Comment #41: Effects of the change from Np=13 to Np=200

IEEE P802.3bs 200GbE and 400GbE Task Force
San Antonio, November 7-9, 2016

Steady-State Voltage v_f ($zp=12\text{mm}$)

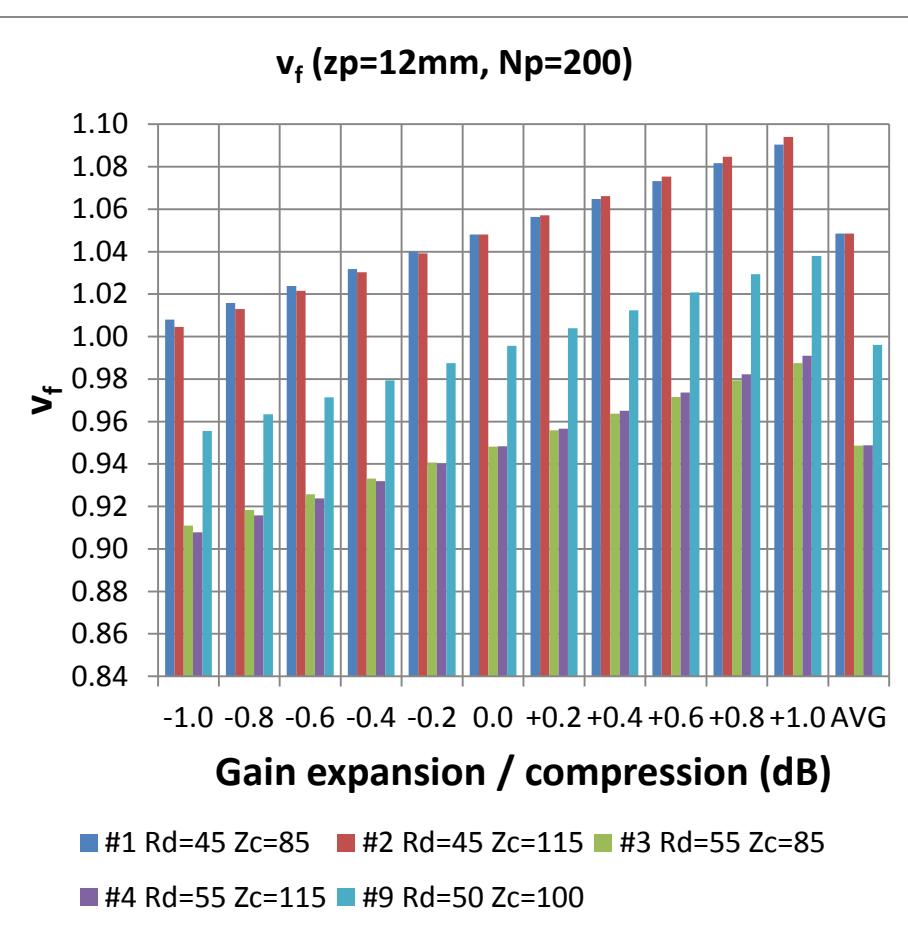
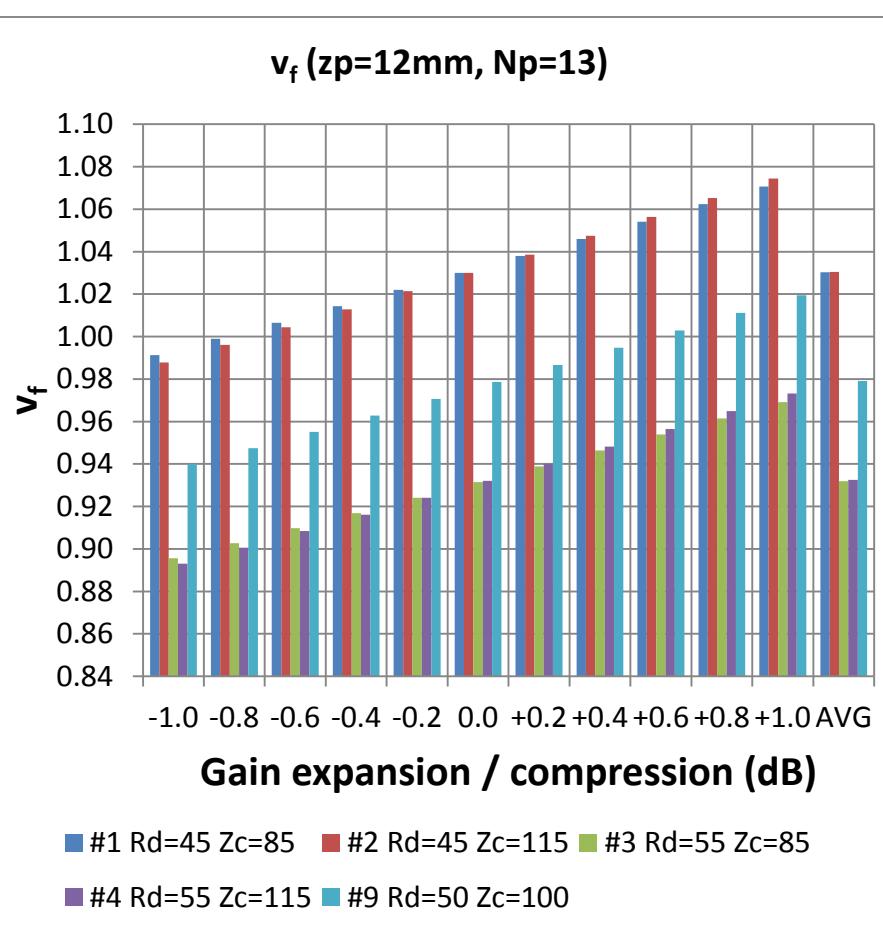
■ Non-negligible increase

- Because a longer fitted pulse captures more long-term ISI

- Suggested remedy of comment #41 updated w/ correct parameters (changes based on simulation results #7 and #8)
 - Change the Steady state voltage v_f (max) from 0.6 V to 0.611 V
 - Change the Steady state voltage v_f (min) from 0.4 V to **0.421** V
 - Change the Linear fit pulse peak (min) from $0.736 \times v_f$ to **0.707** $\times v_f$
 - Update the following COM parameters
 - Av and Afe from 0.45V to 0.445V
 - Ane from 0.63V to 0.644V
- Or, another remedy based on simulation results #9 and #10
 - Change the Linear fit pulse peak (min) from $0.736 \times v_f$ to **0.707** $\times v_f$
 - Change Av and Afe from 0.45V to 0.423V
 - Change Ane from 0.63V to 0.633V
 - Keep v_f (max) as 0.6V and v_f (min) as 0.4V

Steady-State Voltage v_f ($zp=30mm$)

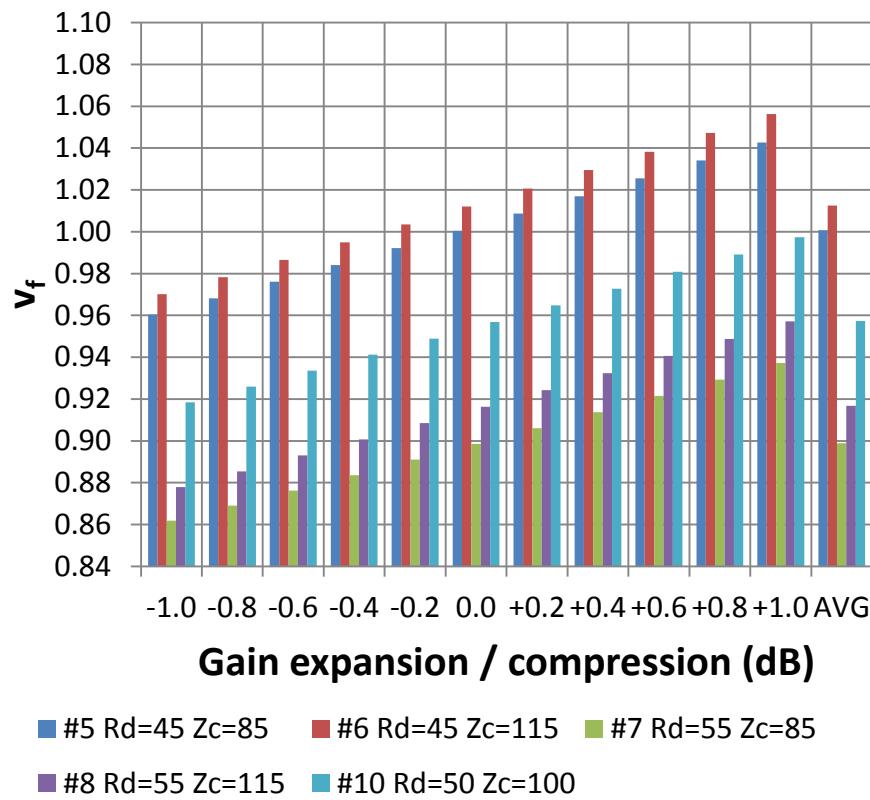
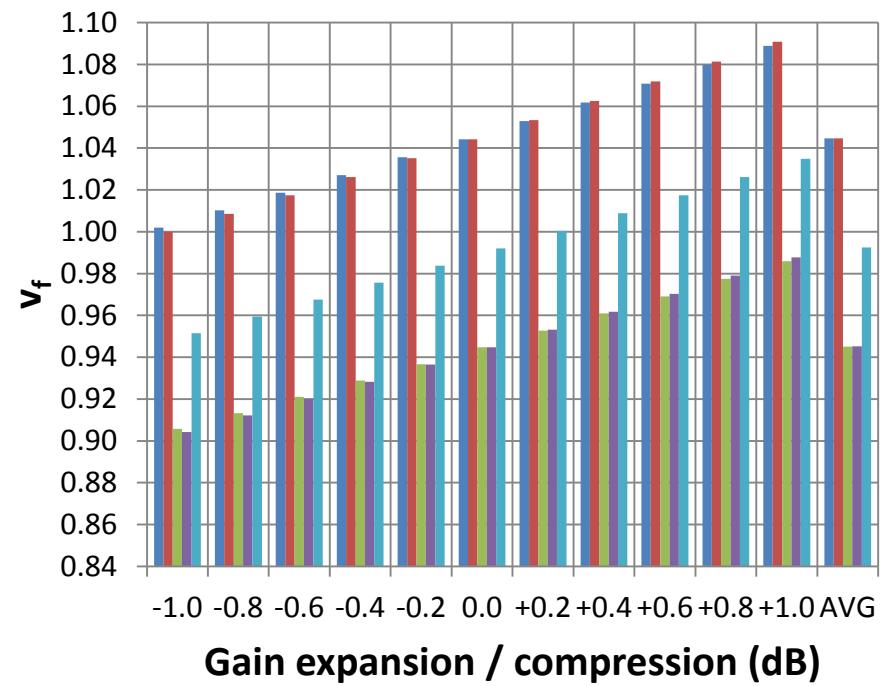
■ Non-negligible increase

- Because a longer fitted pulse captures more long-term ISI

Ratio of p_{\max} to v_f ($zp=12mm$)

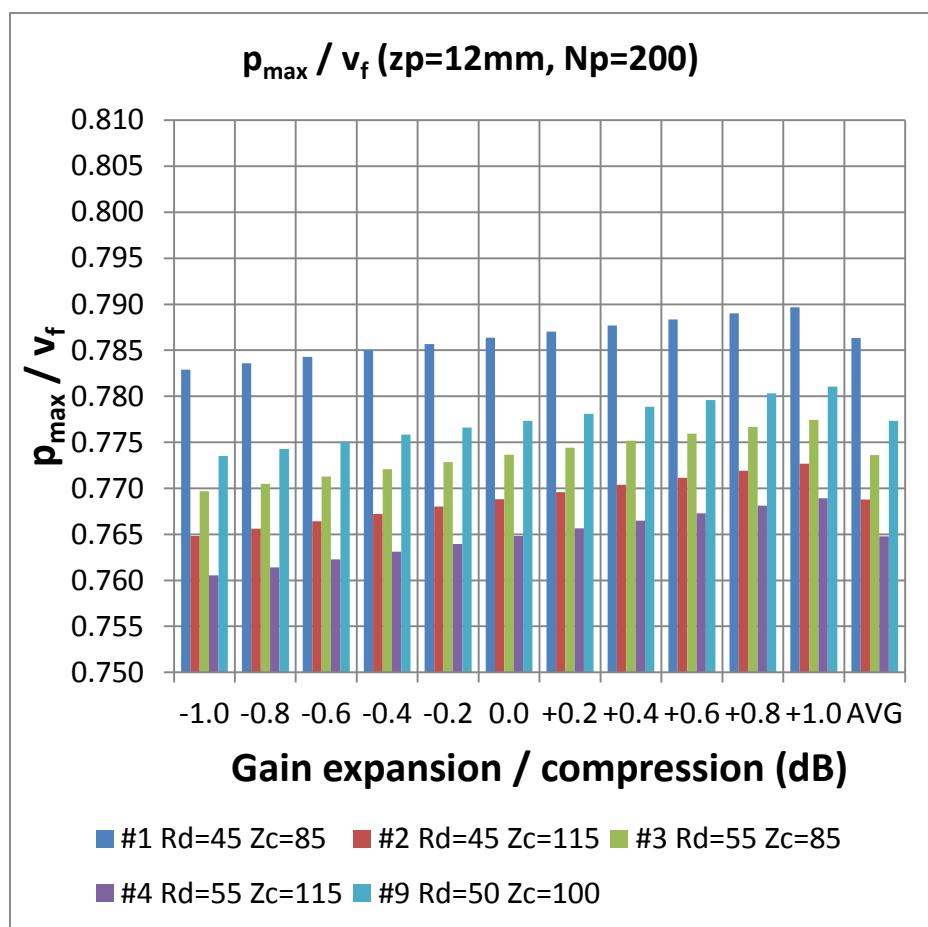
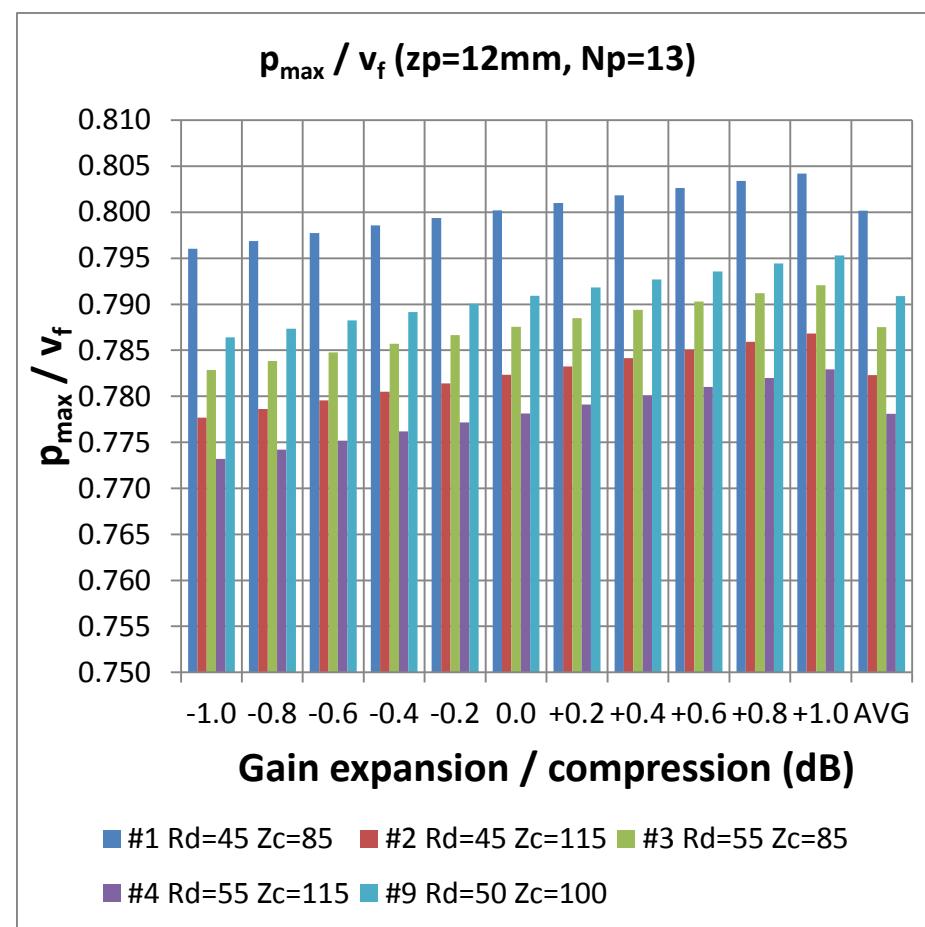
■ Reduced a lot

- Because v_f increases while p_{\max} does not change

Ratio of p_{\max} to v_f ($zp=30mm$)

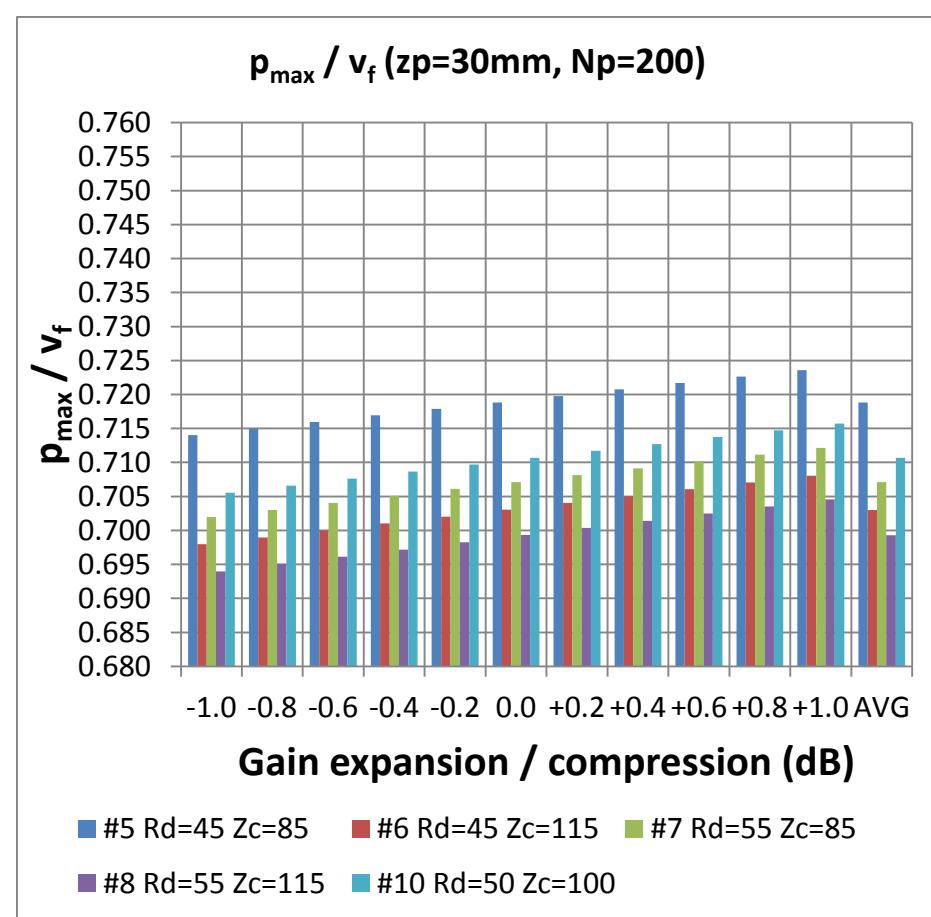
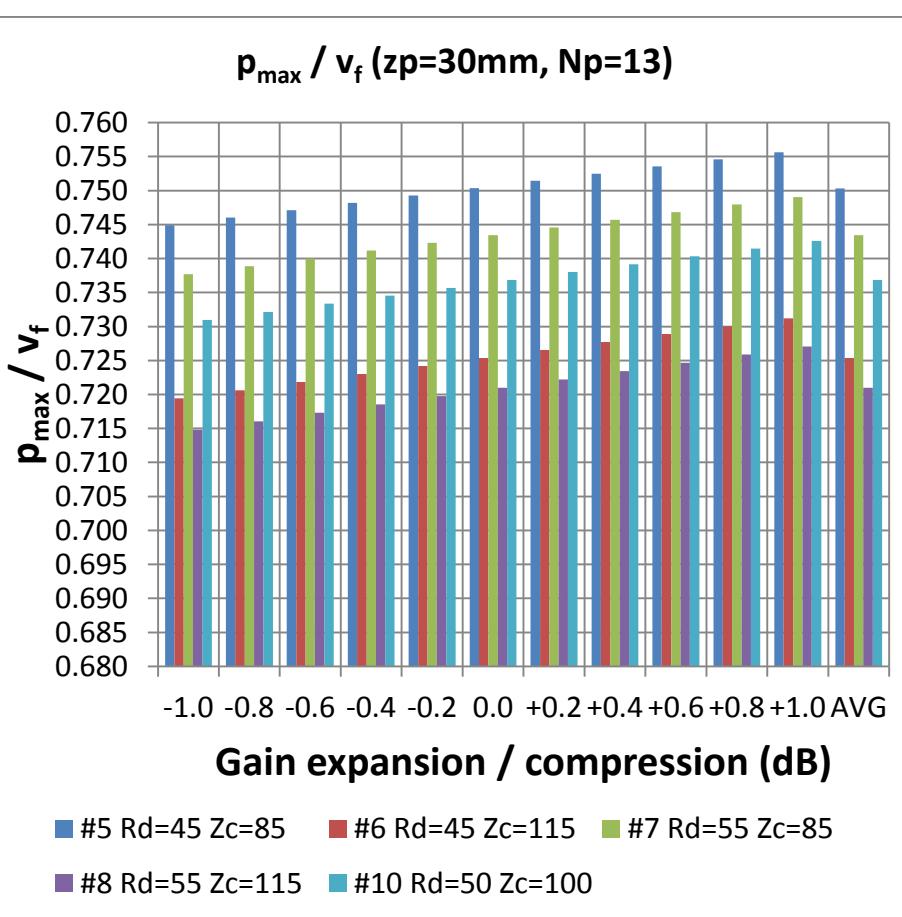
■ Reduced a lot

- Because v_f increases while p_{\max} does not change
